D/DRC Case

1634 Main Street

DESIGN/DEVELOPMENT REVIEW COMMISSION
DESIGN REVIEW DISTRICT
HISTORIC AGENDA
EVALUATION SHEET
Case # 1

NATURE OF REQUEST: Request Certificate of Design Approval for exterior changes and Preliminary Certification for the Bailey Bill

EXTERIOR ELEVATIONS

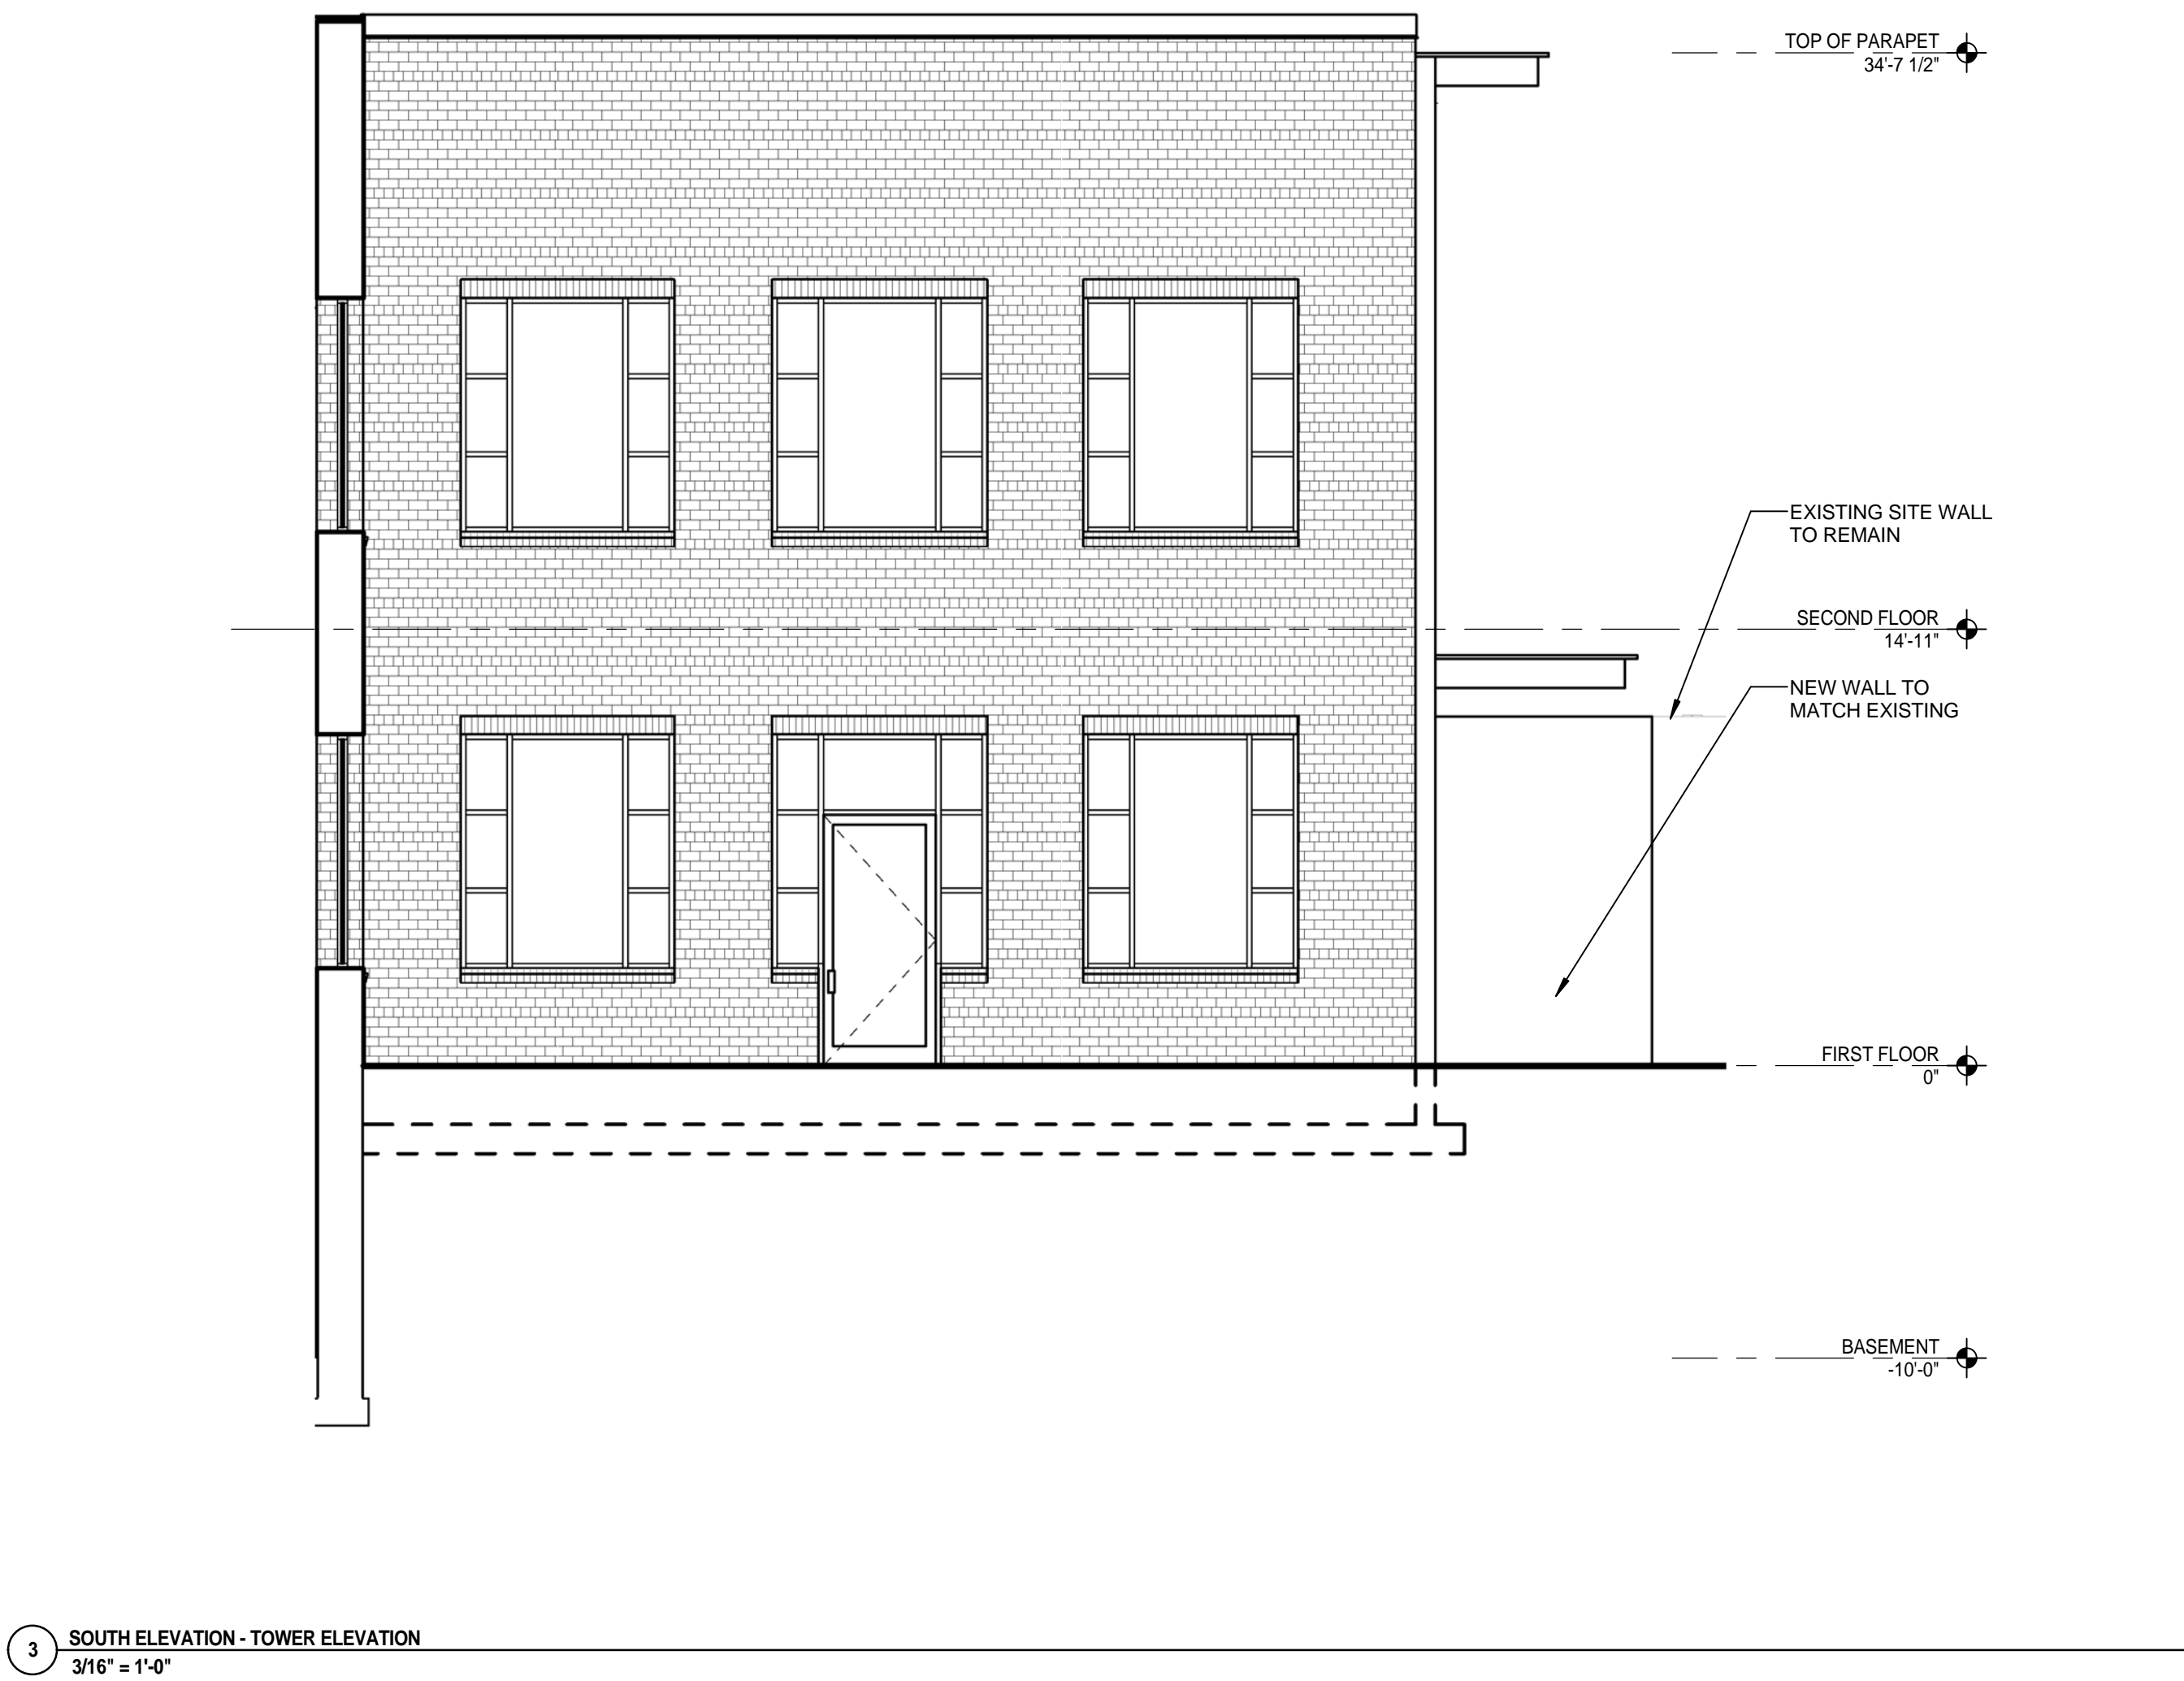
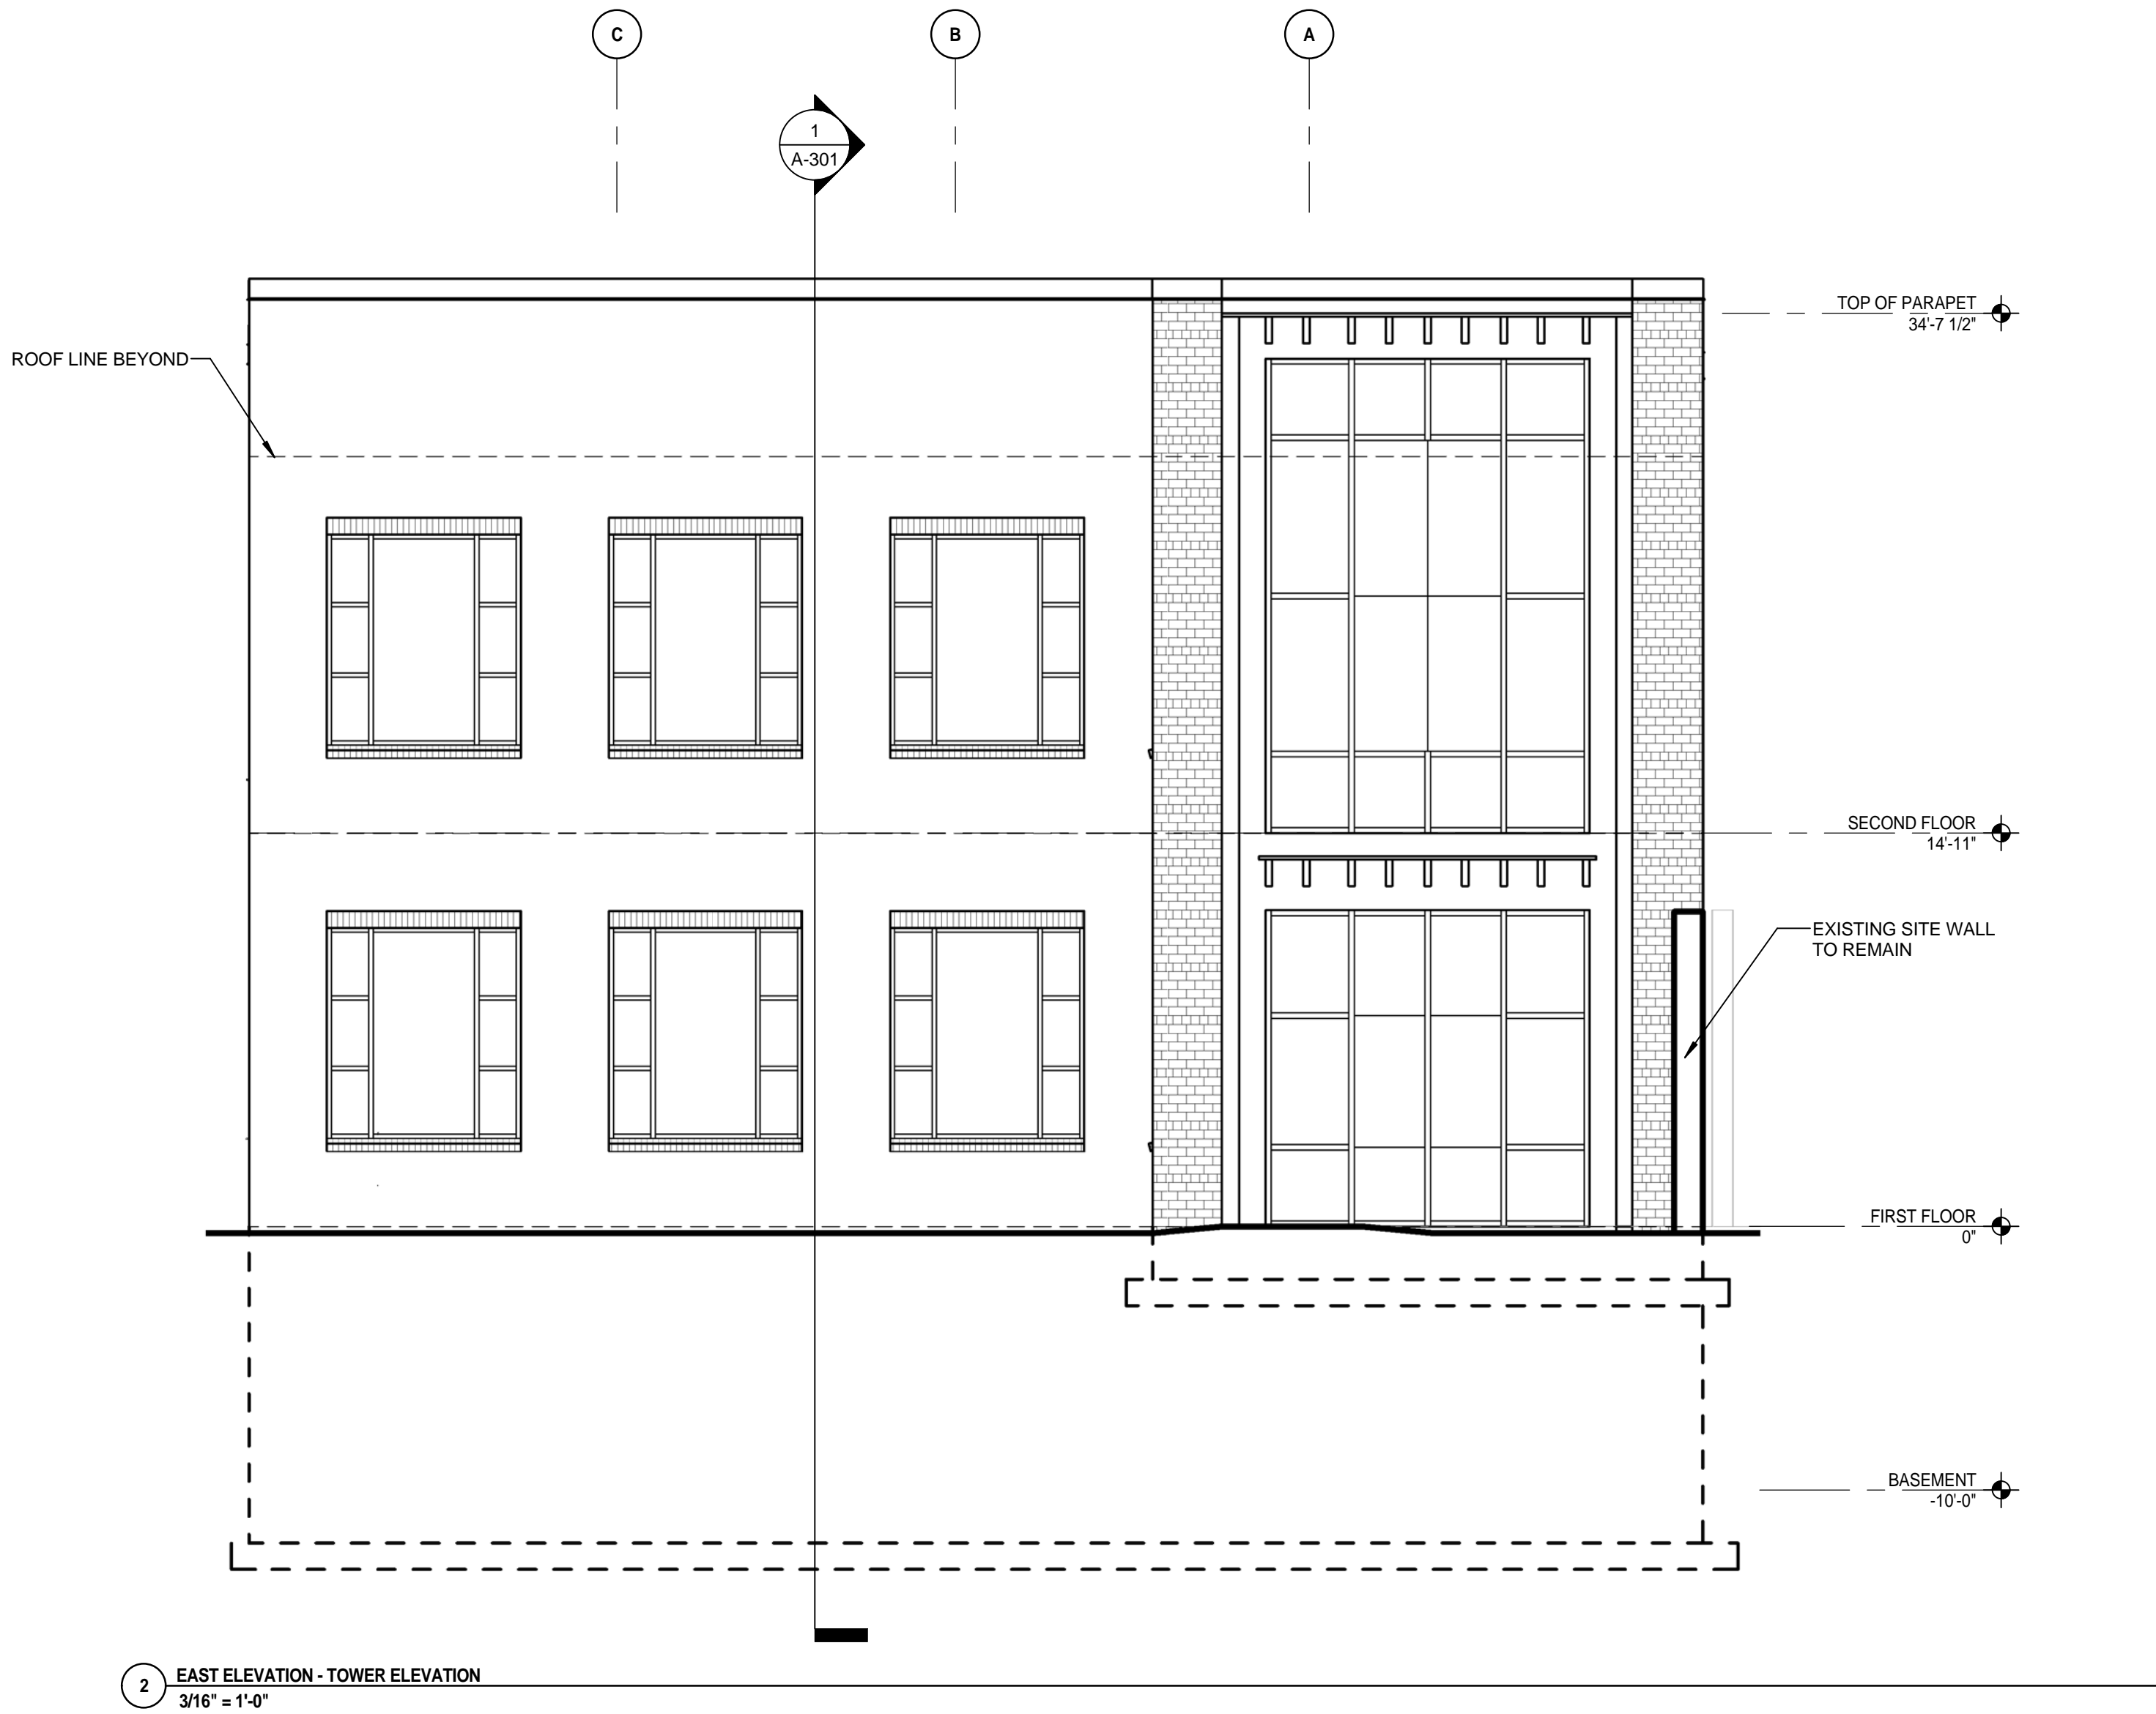
Other work on the building includes opening bricked-in windows along the south elevation, as well as a few doors; this is in an alley that is not public so only those parts visible to the public right of way are reviewed.

submitted at a later date. The submitted drawings are also not correct in their note to remove the iron star vents visible above the second floor windows along the south elevation.

The distinctive cream colored brick on the façade is being retained and repaired. The brick wall on the south elevation has already been painted before; it will be repaired and potentially repainted. Brick detailing in this wall shows the locations of door and window openings, some unusually shaped, with header courses and jack arches as lintels. These details will remain as infill brick is removed beneath them and new doors and windows are installed.
